Technical Service Bulletin

Subject: CHECK ENGINE LIGHT ON WITH DTCs P24C6:00, P24AE:00, P24B1:00 AND/OR P24AF:00	Bulletin No.: 01-003/20
	Last Issued: 02/13/2020

APPLICABLE MODEL(S)/VINS
2018-2019 CX-5 SKYACTIV-D 2.2

PROPER ORIENTATION OF PARTICULATE MATTER (PM) SENSOR:

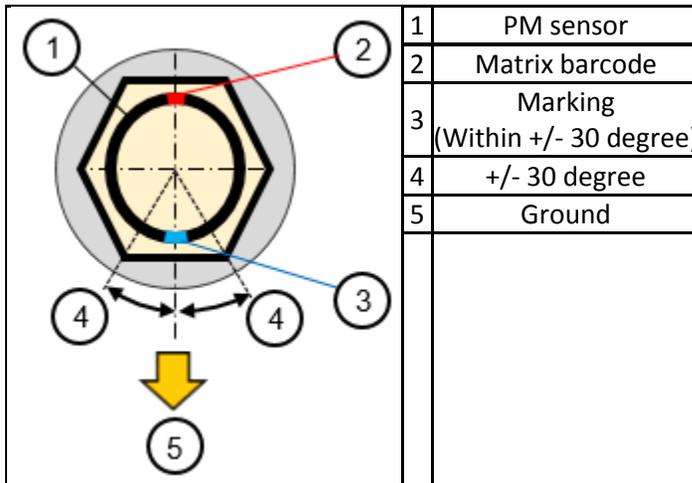
NOTE: To reduce water accumulation in the PM sensor, follow the steps below when installing the sensor so the sensor element faces upward.

1. Find the matrix barcode (2) on the PM sensor (1) that faces the same direction as the sensor element (See "Location of matrix barcode" below).
2. Mark (3) the sensor body 180 degrees opposite of the matrix barcode and harness side of the free nut.
3. Install the PM sensor so that the marking faces downward to the ground (5) +/- 30 degrees (4).

NOTE: When tightening the free nut, the sensor housing may turn together. For the best result, temporarily tighten the nut holding the sensor housing at 15 degrees before the target angle, then tighten to the specified torque.

- **Tightening torque: 30-44 ft·lbf {40-60 N·m, 4.1-6.1 kgf·m}**

Location of the matrix barcode:

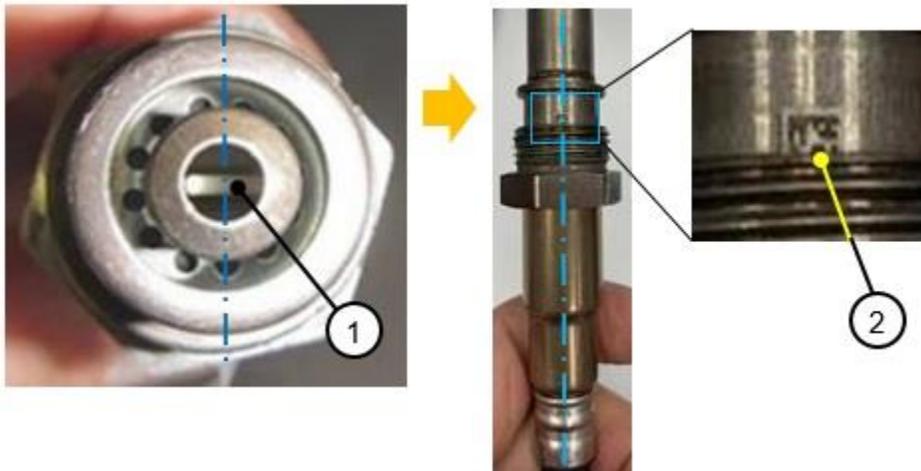
Locate the sensor element plate (1) and imagine the dashed line as shown below. The matrix barcode (2) is printed at the crossing of the line and either side of the sensor housing.

NOTE: If the matrix barcode is not found, it may be hidden under the free nut. This may be due to a variation in manufacturing.

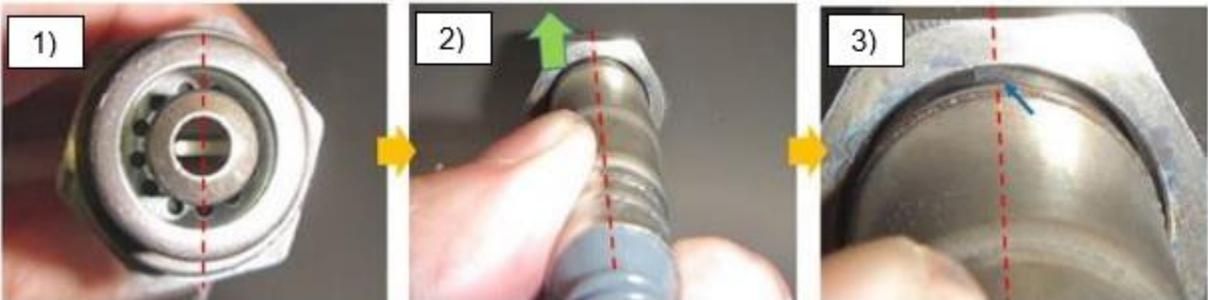
Use the following procedures to locate it the matrix barcode.

Procedure (A) Looking from the sensor element side:

- 1) Locate the sensor element plate.
- 2) Push the free nut downward.
- 3) Hold the nut to create clearance, then inspect the area shown below by the arrow.

**Procedure (B)** Looking from the harness side:

- 1) Locate the sensor element plate.
- 2) Push the free nut upward.
- 3) Hold the nut to create clearance, then inspect the area shown below by the arrow.
